SR 25 CO/West Bay Street From I-516 to the Bay Street Viaduct

NHS00-0002-00(923), P.I. No. 0002923
Chatham County, Georgia

Value Engineering Study Report

September 2009

ACT. NO.
ROW-4
Sht. 2 of 5

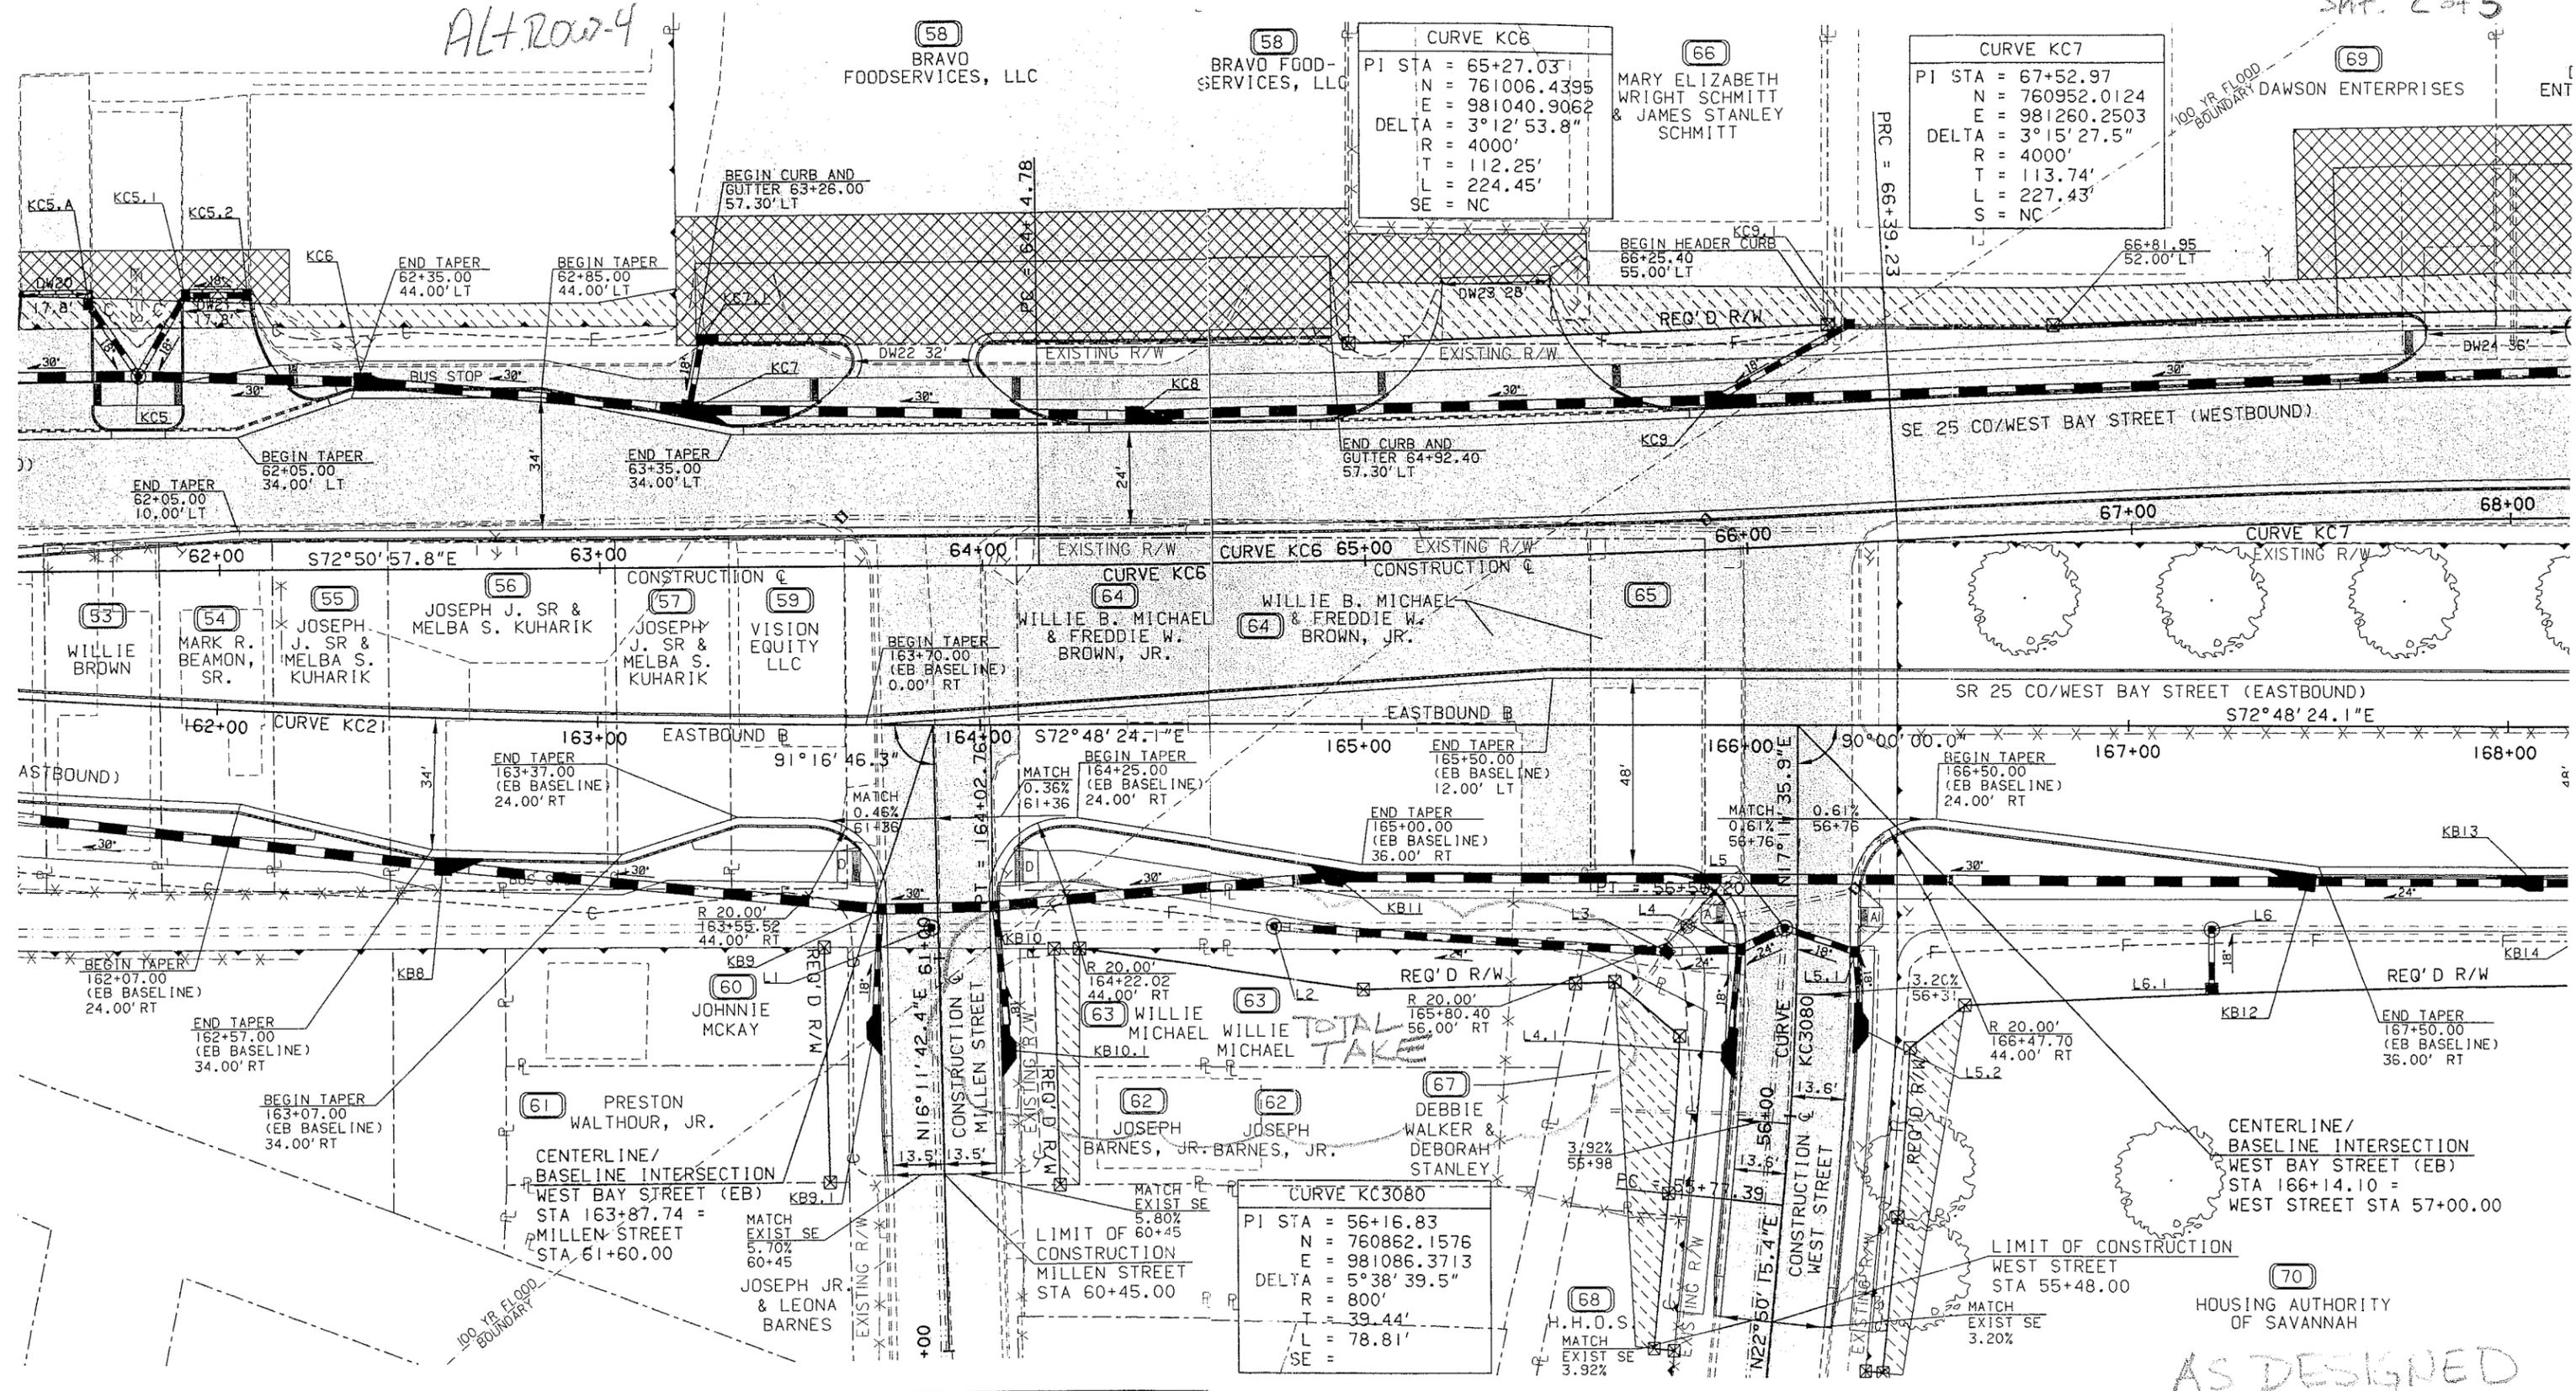
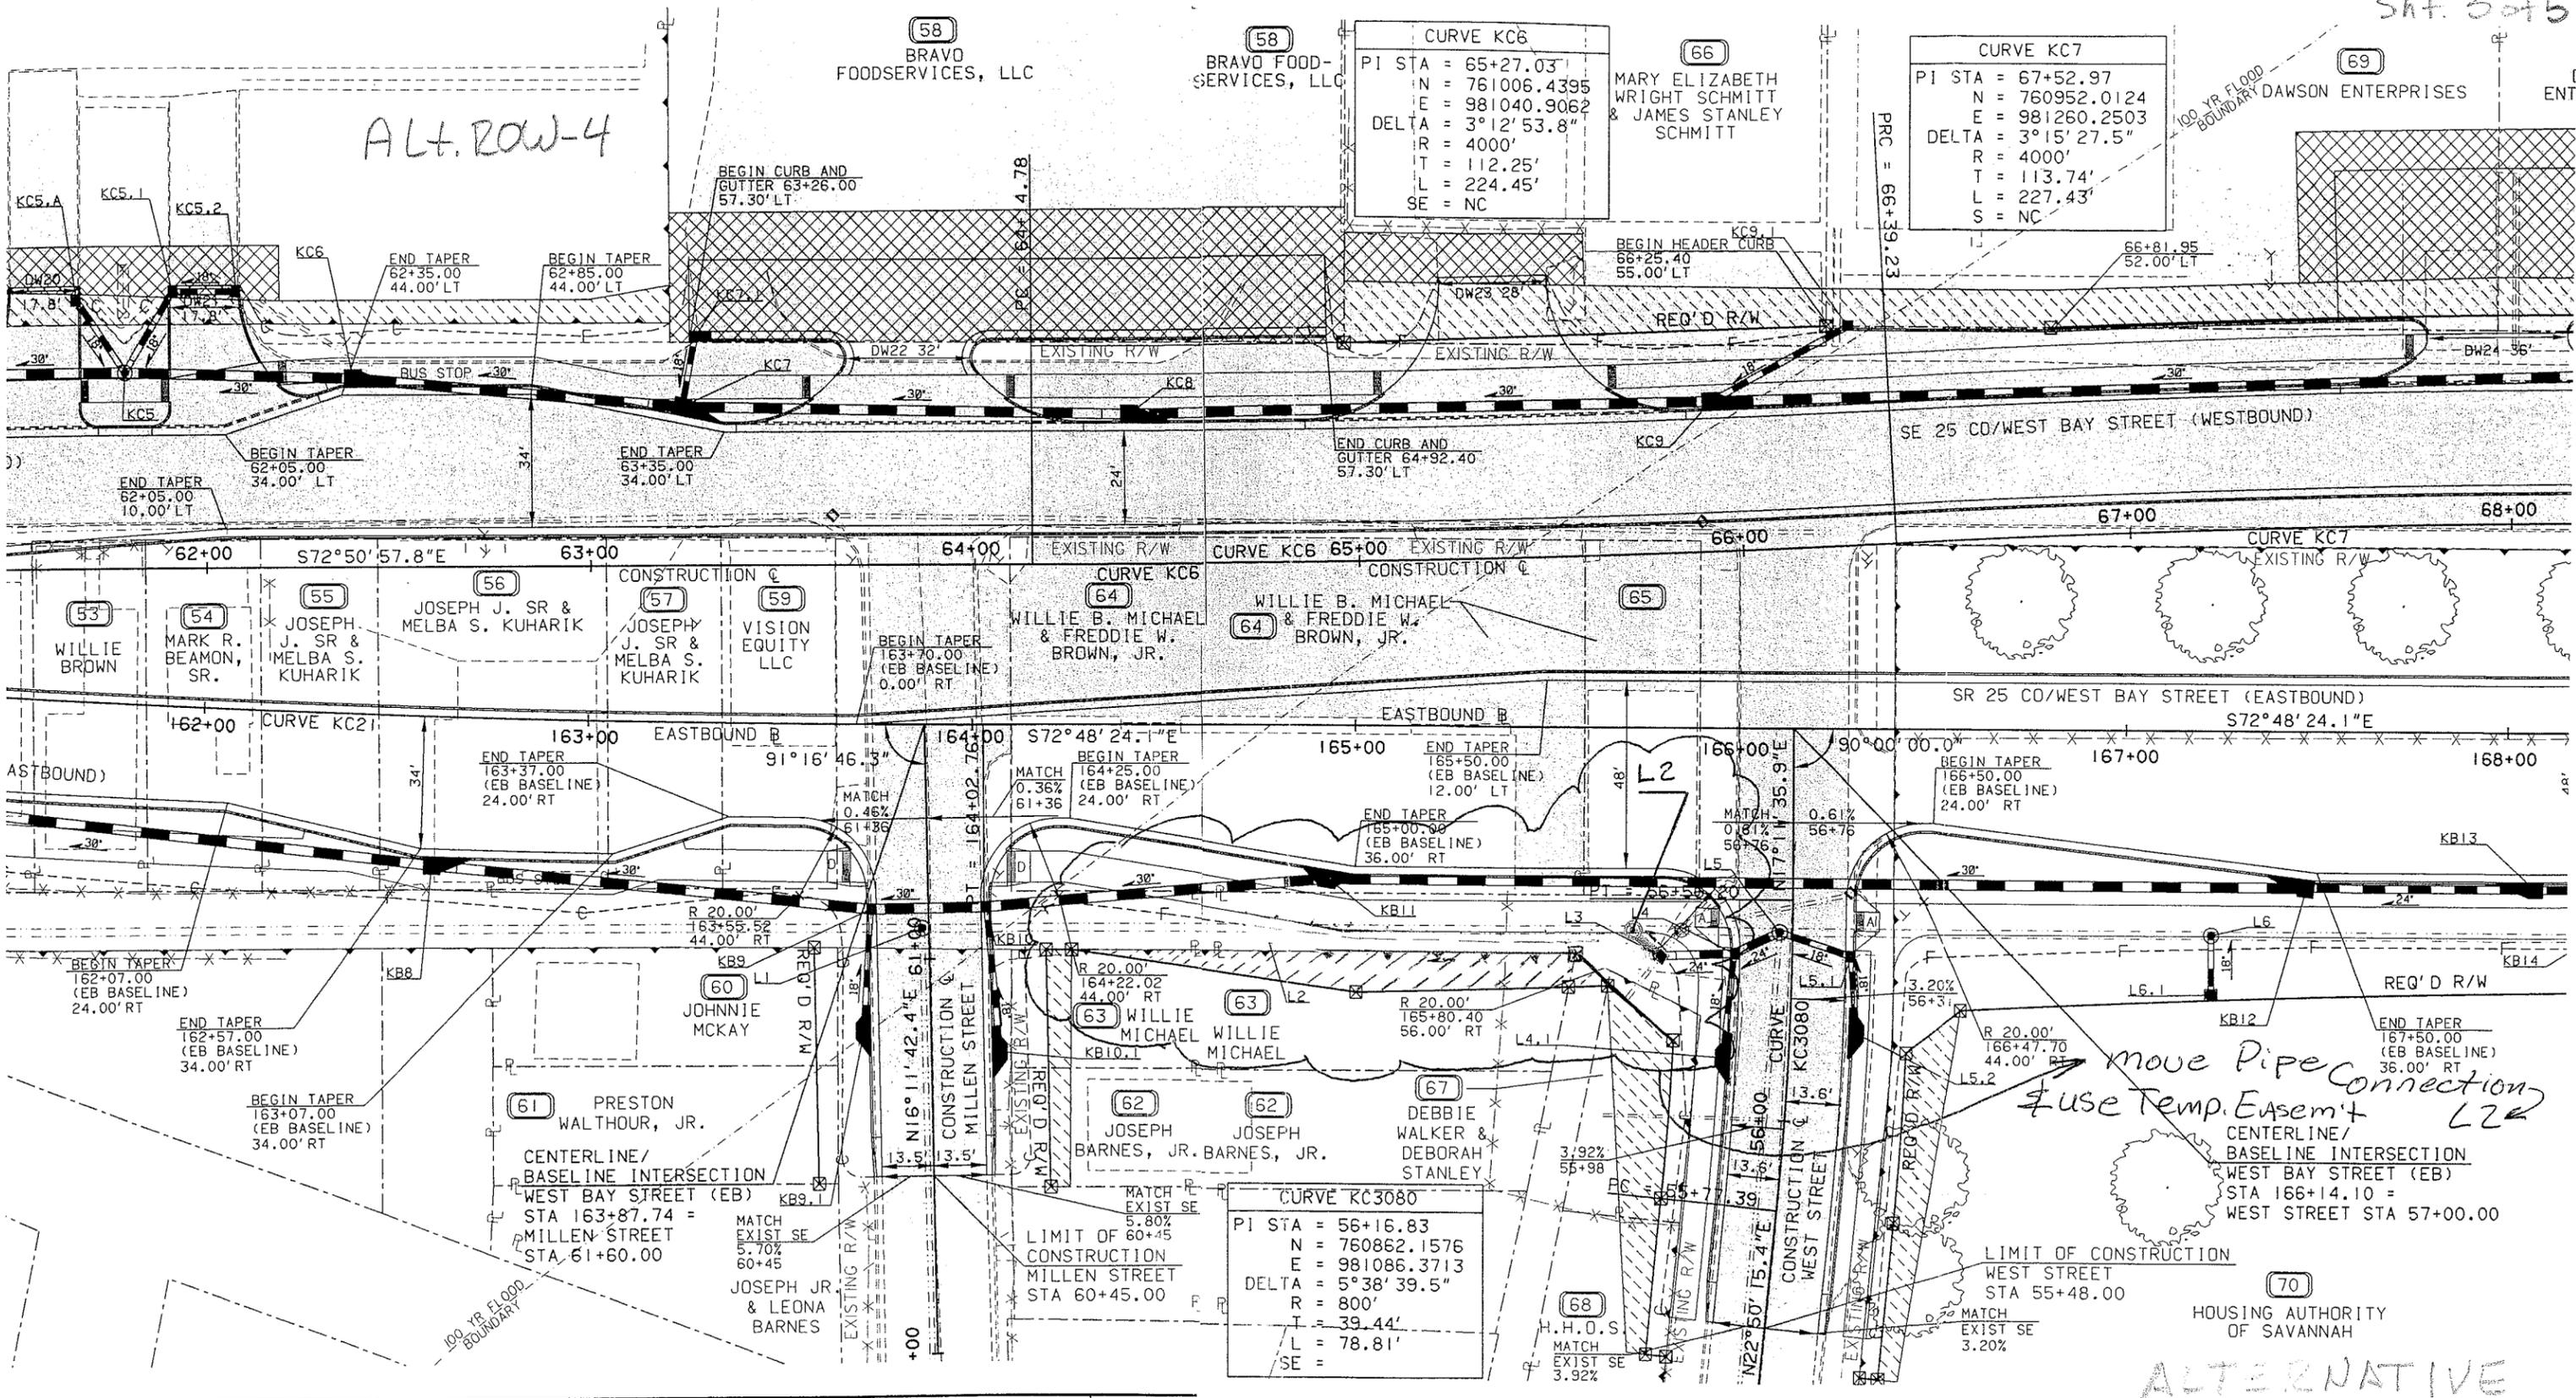
The proposed junction of the new 24 in storm pipe, L2, and the existing storm drain pipe at Sta. 164+80 right can be moved (see sketch) to avoid impacting Parcel 63. The GDOT Right-of-Way Acquisition Information Sheet shows Parcel 63 as a total take. By moving the storm drain pipe, the construction limits will be off of the parcel. Use a temporary easement, if necessary, for the temporary erosion control and construction “space.”

Change the storm drain pipe design along Parcel 63 to avoid total take and change the right-of-way to a temporary easement.

ALTERNATIVE NO.: **P-1**

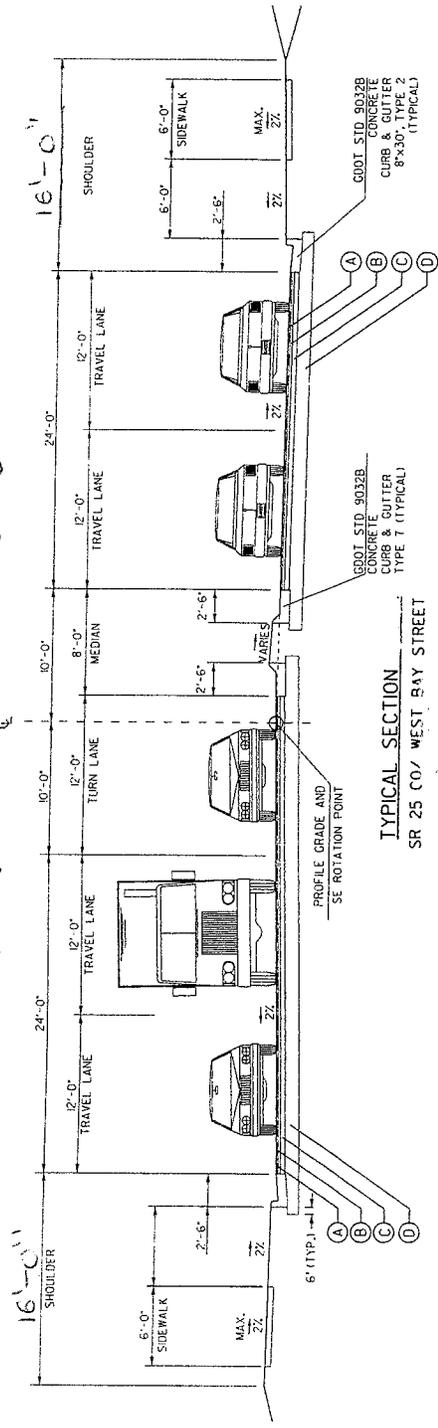
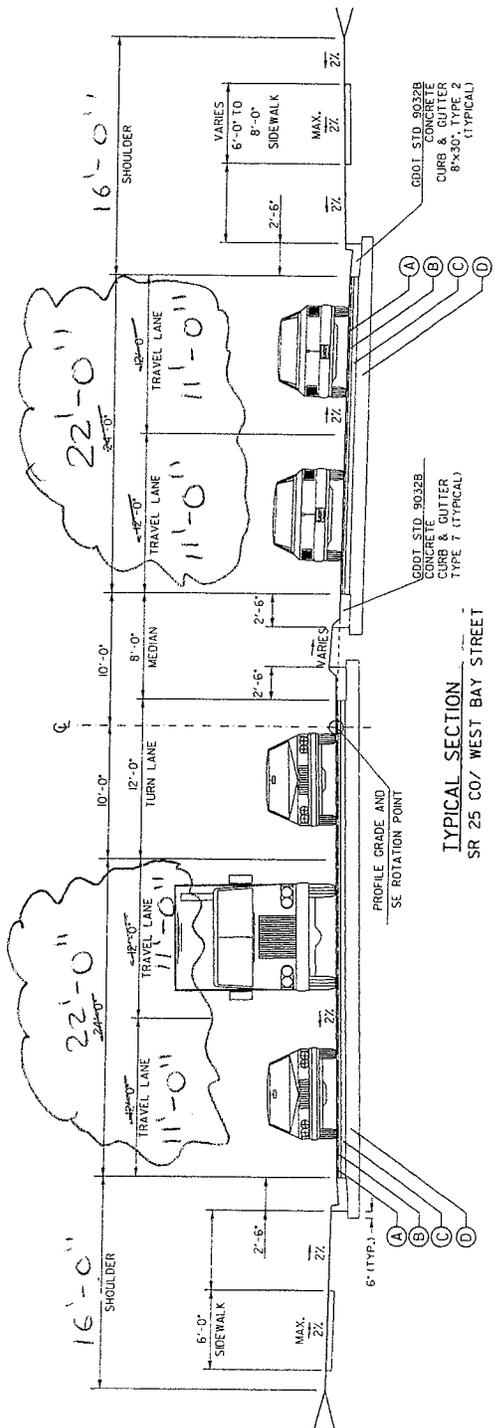
The interstate freeways passing through Atlanta have 11-ft-wide lanes. Traffic flows smoothly even at speeds greater than 70 mph. On West Bay Street where the speed limit is 35 mph, construction of 11-ft-wide lanes will pose little danger. With 24-in-wide gutters, the effective travel width will be 11 ft + 2 ft = 13 ft. Even if the gutters are reduced to 18 inches as proposed in Alt. No. CG-1, the effective width is still 12 ft 6 in.
